# TOWN OF KITTERY

### **ITEM 3—5 Whipple Road—Major Site Plan — Preliminary Review**

Action: accept site plan as complete. Schedule site walk/public hearing. Mike Sudak, on behalf of owner/applicants PB Real Estate Holdings LLC, request approval to construct a 3,400 square foot commercial facility containing a butcher’s shop and restaurant, along with associated parking and utilities, on the property of 5 Whipple Road, Tax Map 9, Lot 134, in the Business Local (B-L) Zone.

**RE: Minor Site Plan Review Application – Waiver Request Narratives  
Maine Meat Butcher & Restaurant  
5 Whipple Road, Kittery, Maine (Tax Map 9, Lot 134)**

OVERALL SITE PLAN  
 MAINE MEAT BUTCHER & RESTAURANT  
 5 WHIPPLE ROAD, KITTEERY, MAINE

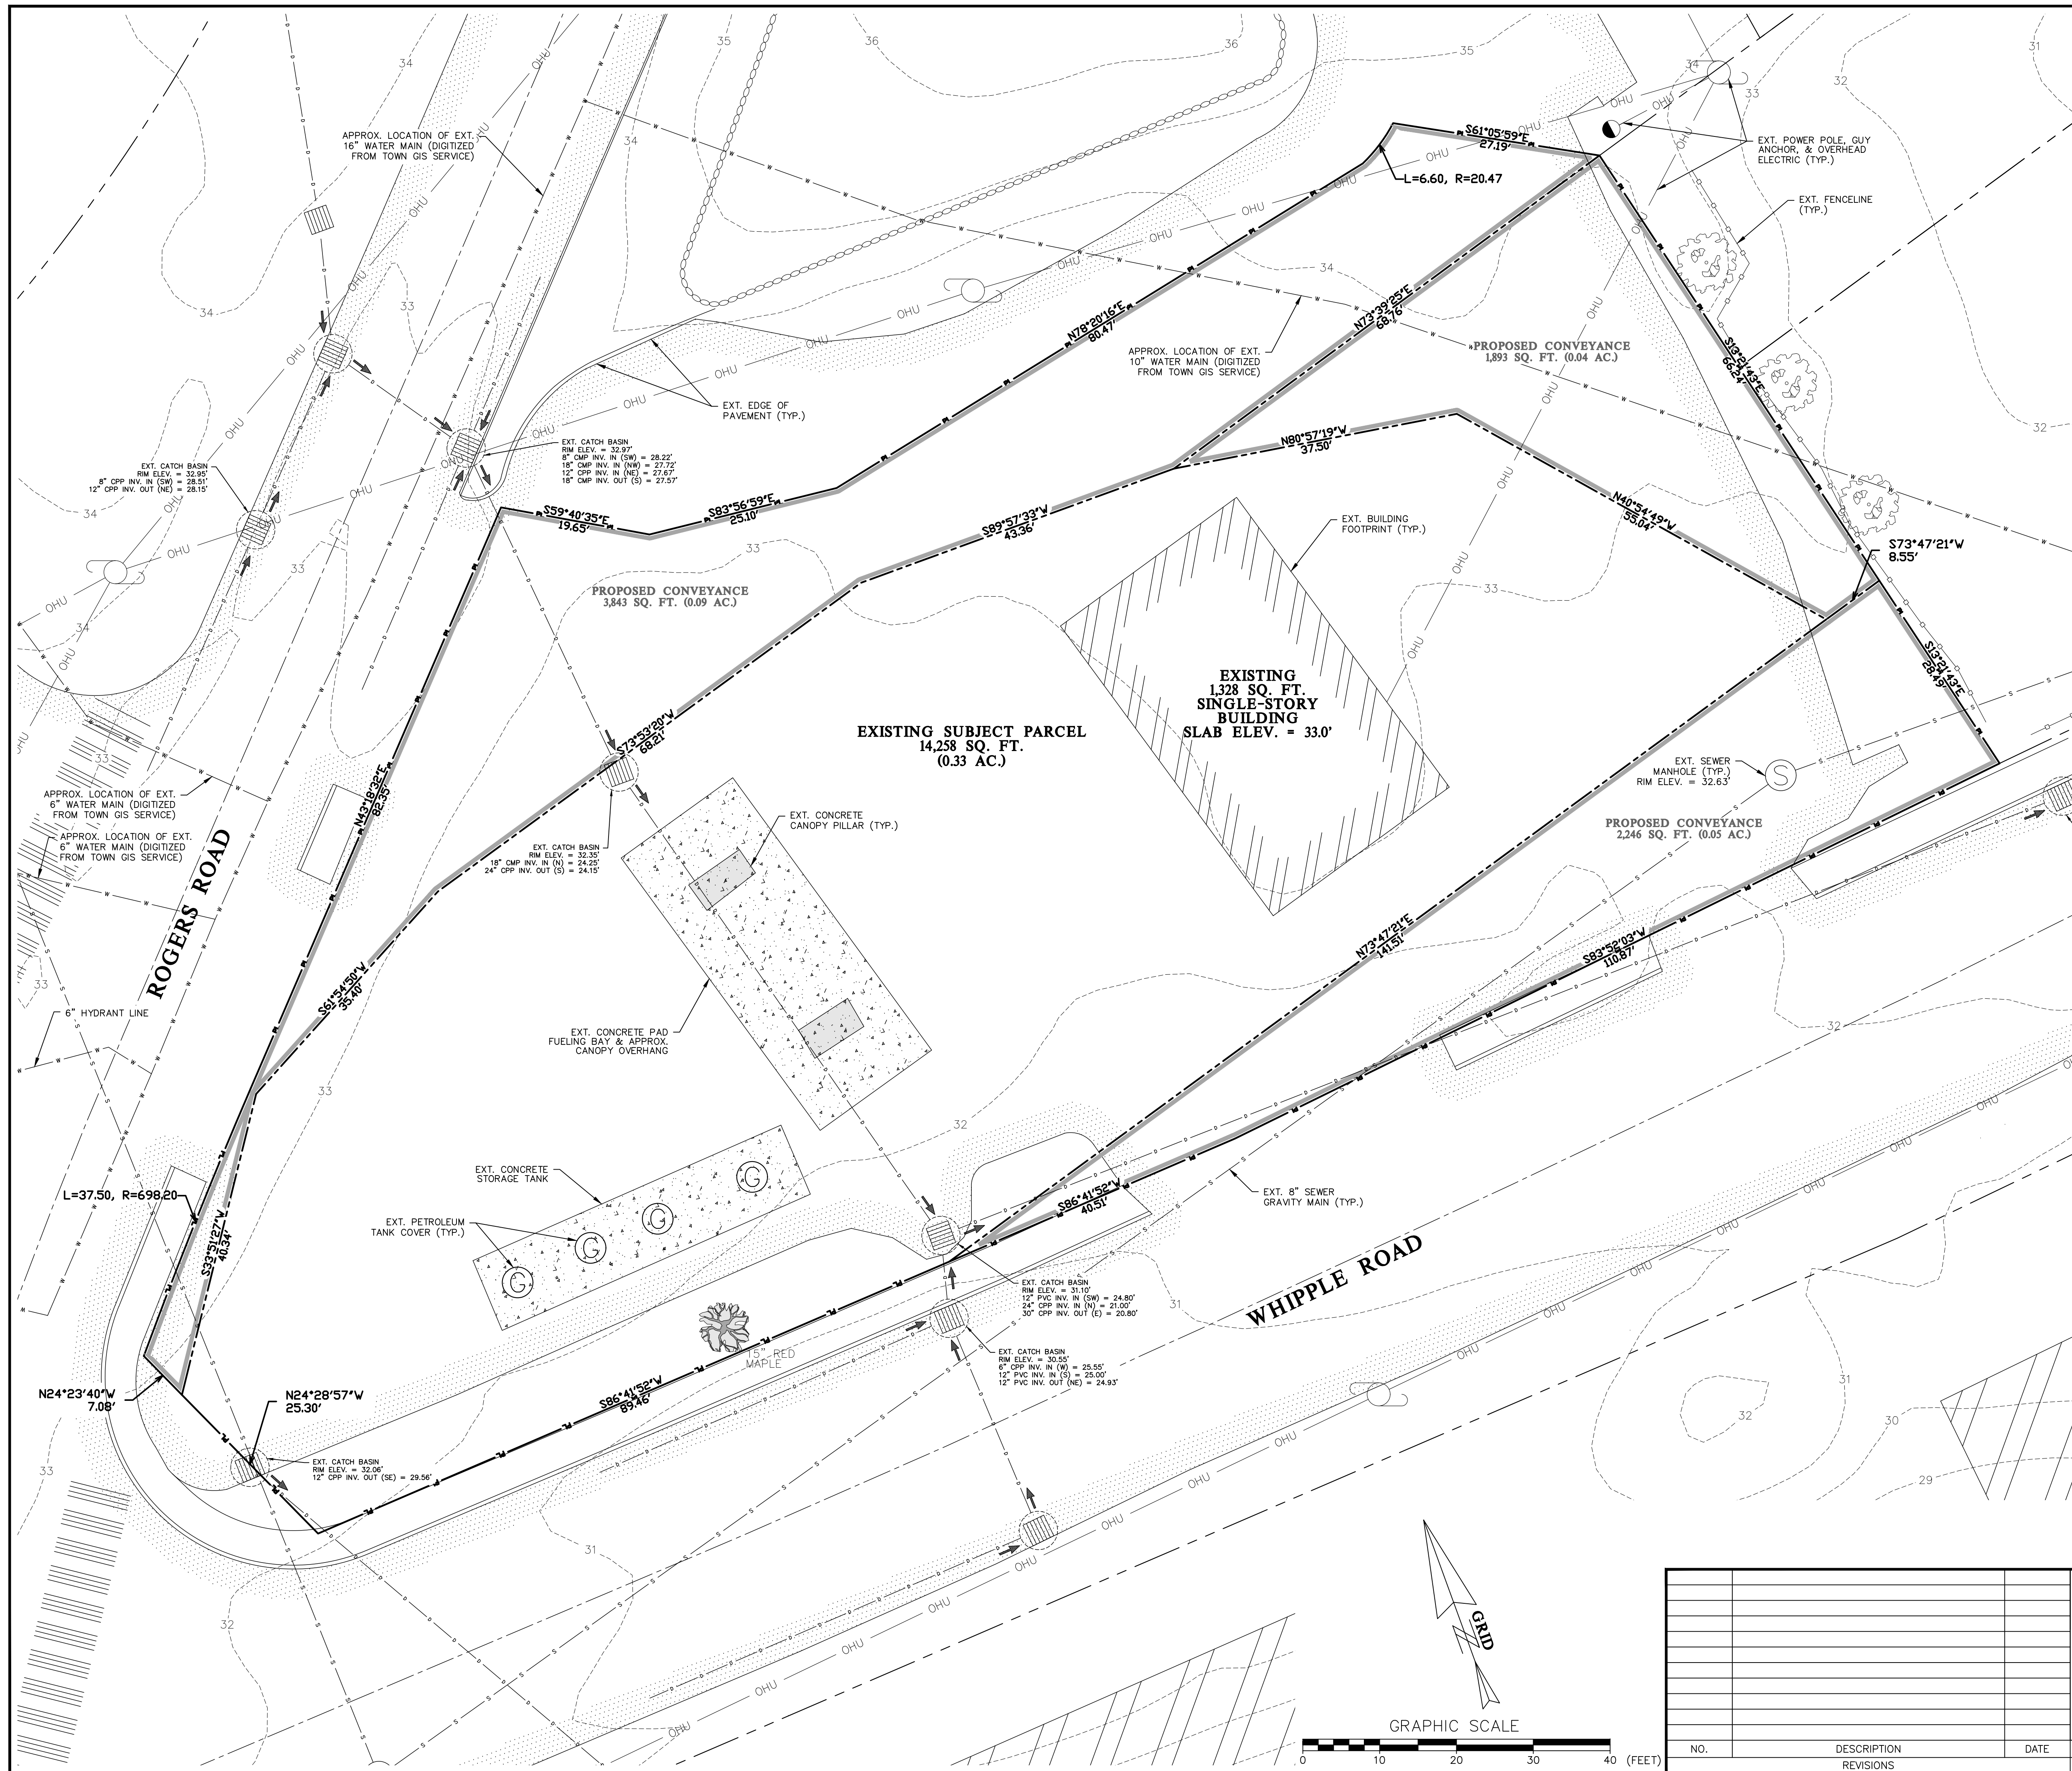
#### Sheet 1 - Overall Site Plan

**EXISTING CONDITIONS PLAN**  
MAINE MEAT BUTCHER & RESTAURANT  
5 WHIPPLE ROAD, KITTEHY, MAINE

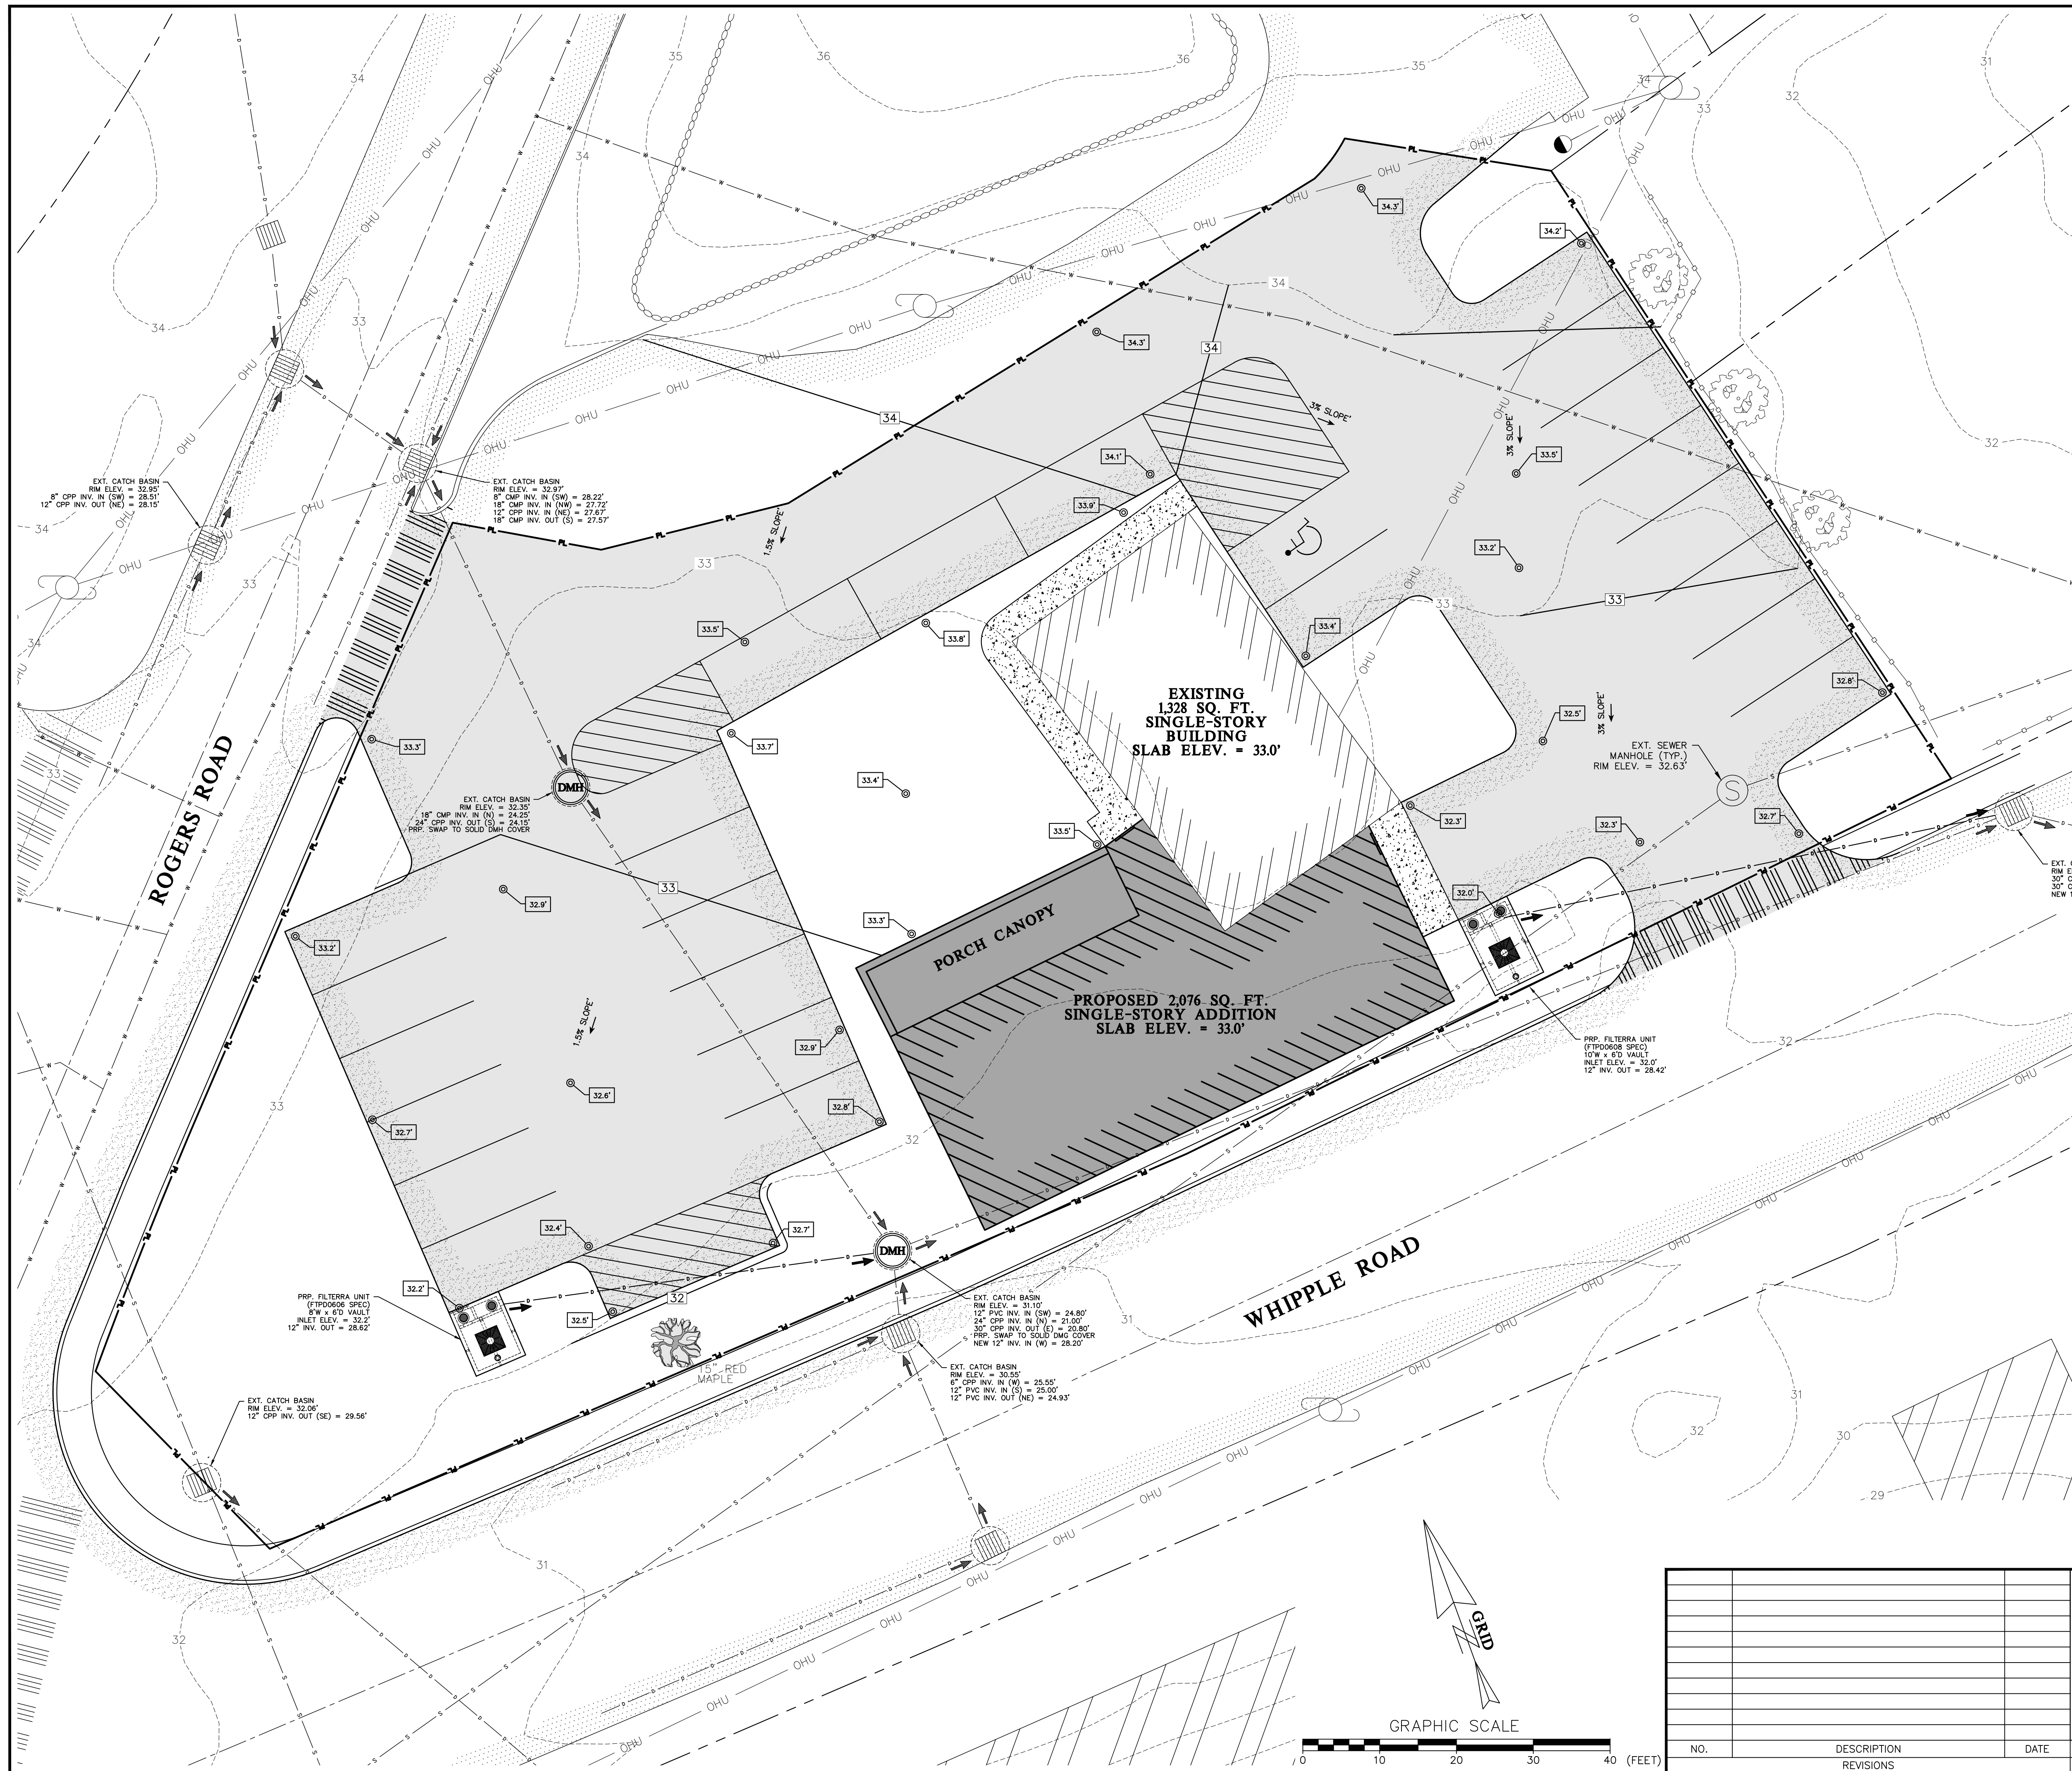
#### Sheet 2 - Existing Conditions Plan

1. The existing fire hydrant referenced in General Notes 12 on Sheet 1 should be shown on the plan.
2. The existing water and sewer services, including materials and sizes, should be shown on the plan.
3. The limits of the existing pavement should be shown on the plan.

STORMWATER: EXISTING CONDITIONS  
 MAINE MEAT BUTCHER & RESTAURANT  
 5 WHIPPLE ROAD, KITTERY, MAINE

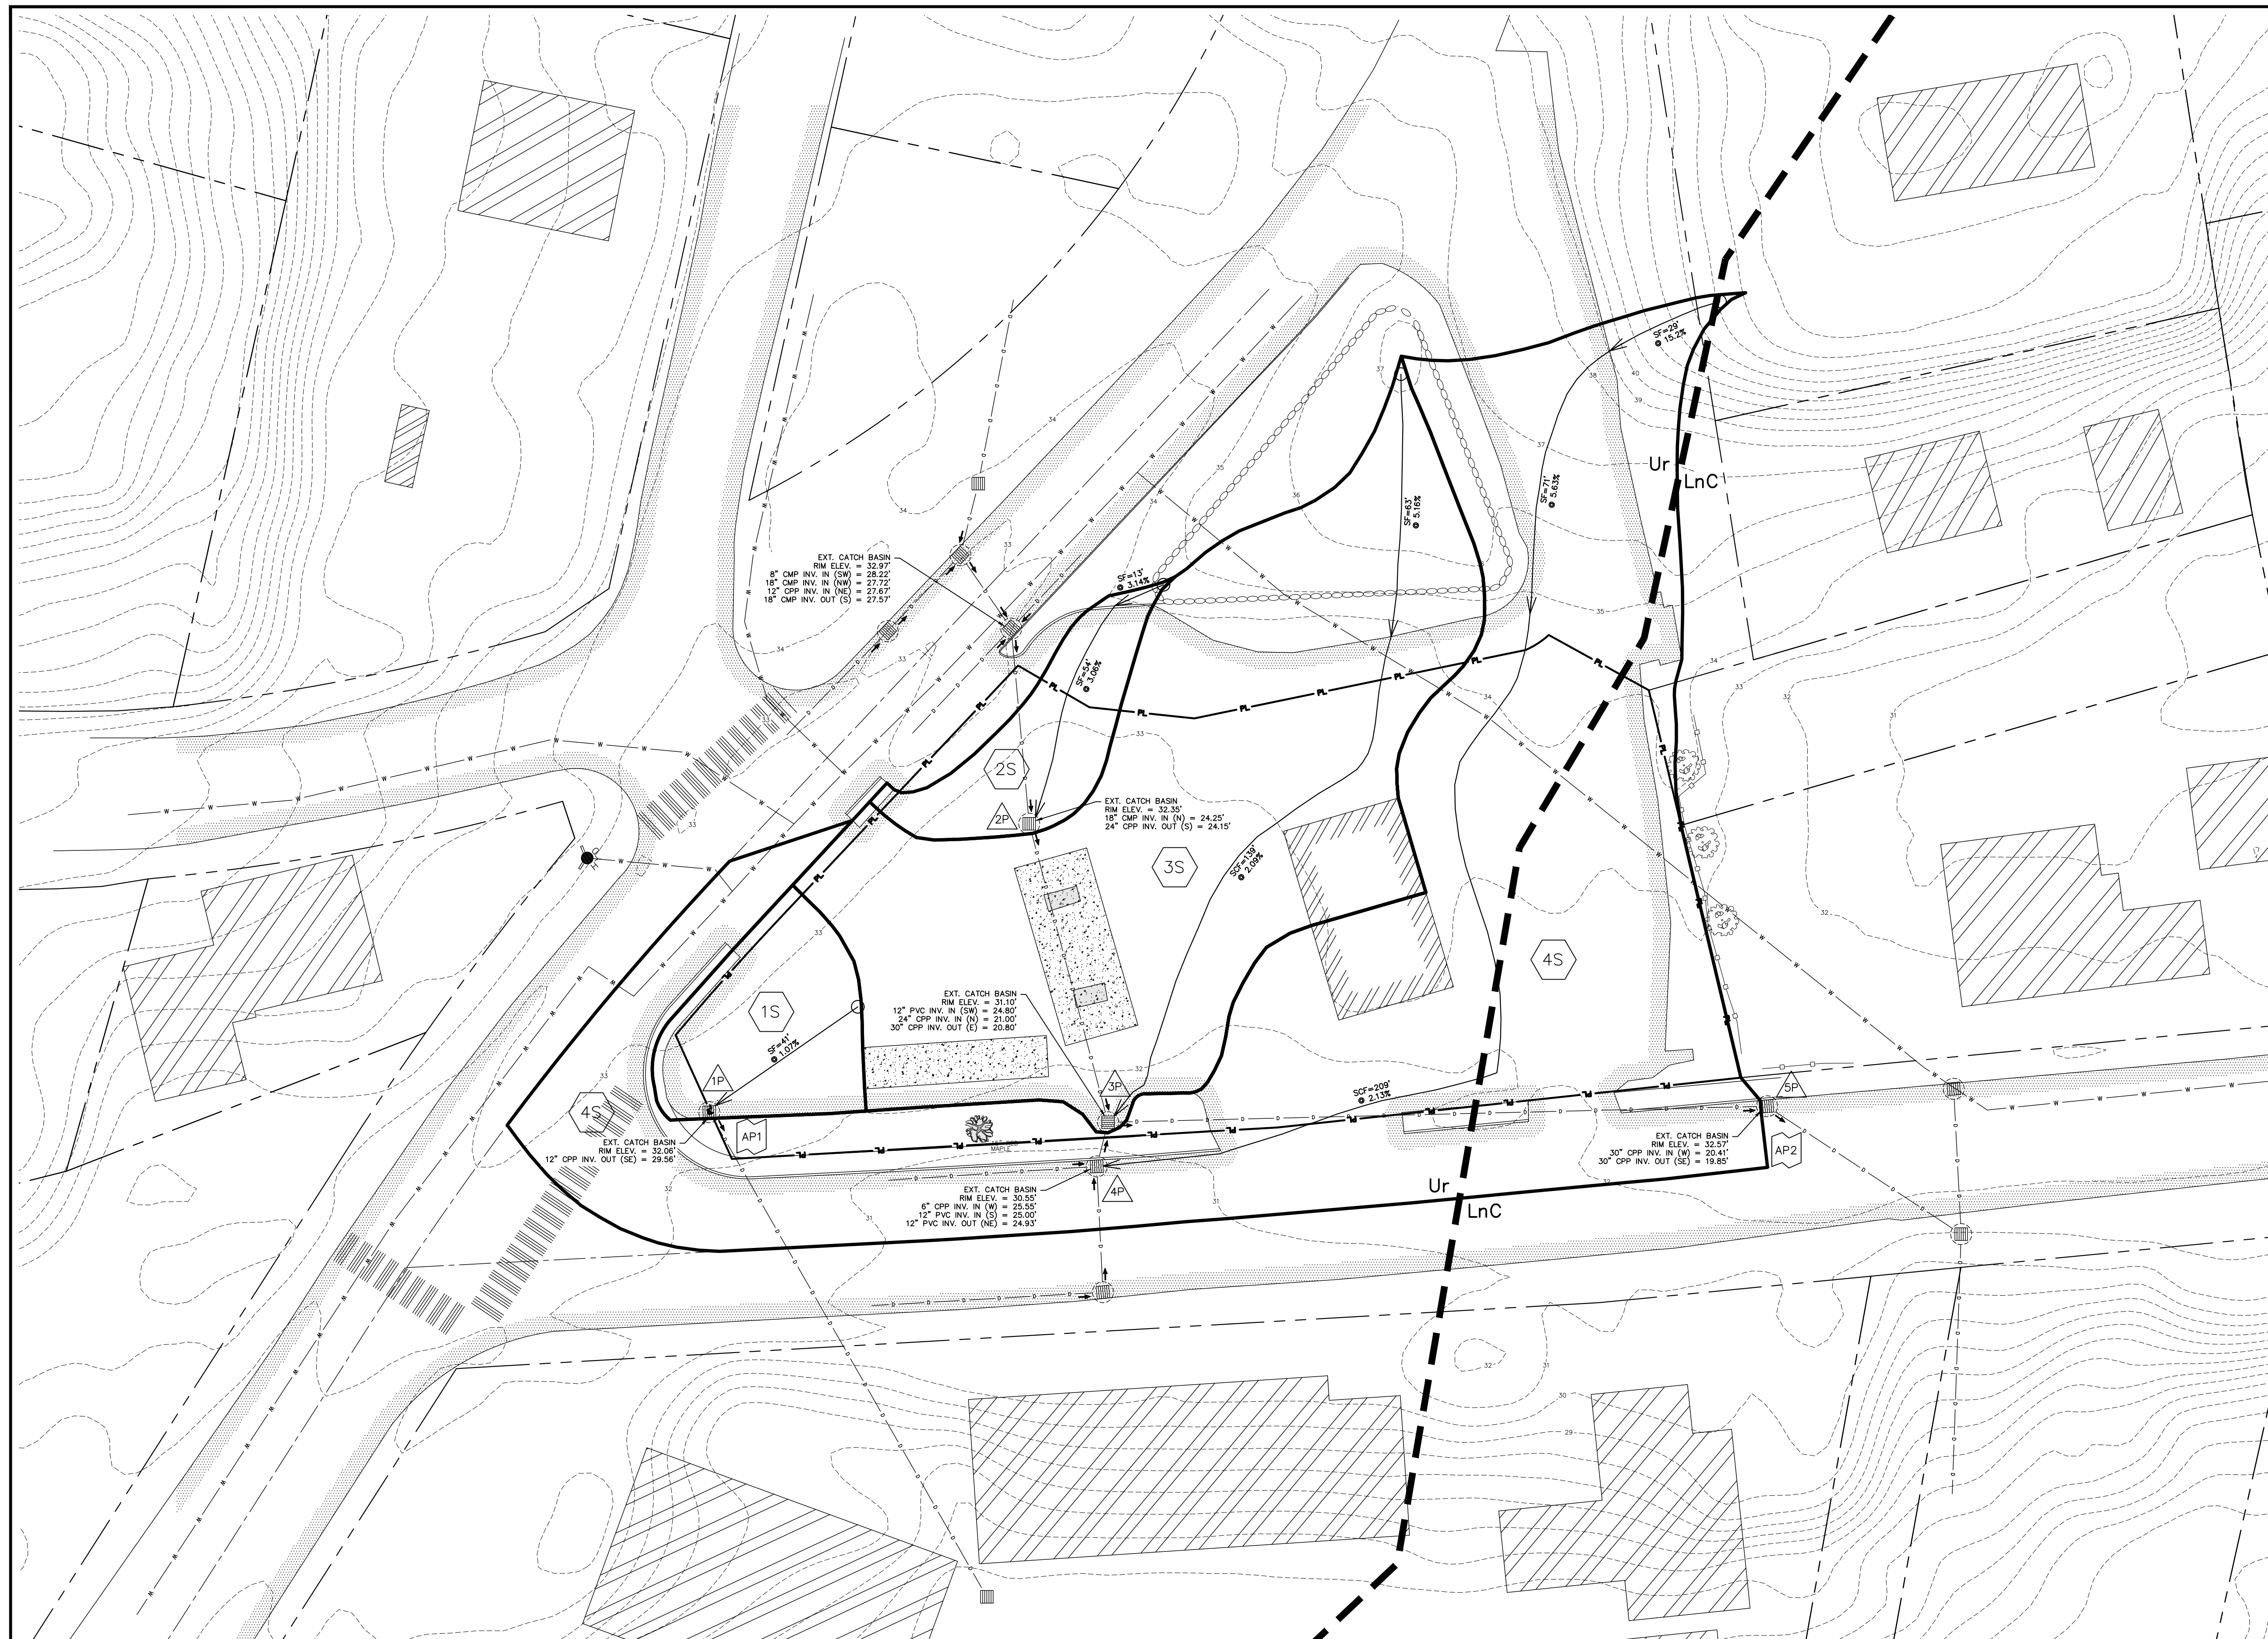
#### Sheet 7 – Stormwater: Existing Conditions
